McCULLOCH SERVICE BULLETIN

NO. 1690

MODEL Pro Mac 510 DATE June 1, 1979

SUBJECT Model Number 600018 (14-)

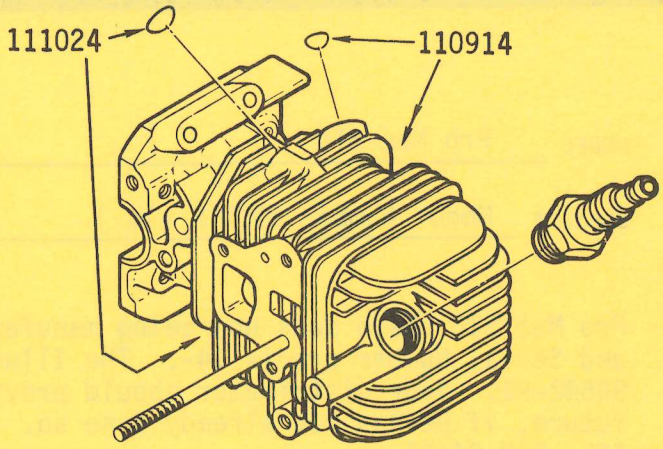
2. Connecting Rod Assembly, P/N 94135, contains Wrist Pin Needle Bearing, P/N 110984. This bearing is pressed into the connecting rod until it protrudes an equal amount on each side, no more than .005" (.13mm).

NOTE: This needle bearing cannot be used as replacement in connecting rods originally equipped with Caged Bearing, P/N 110933.
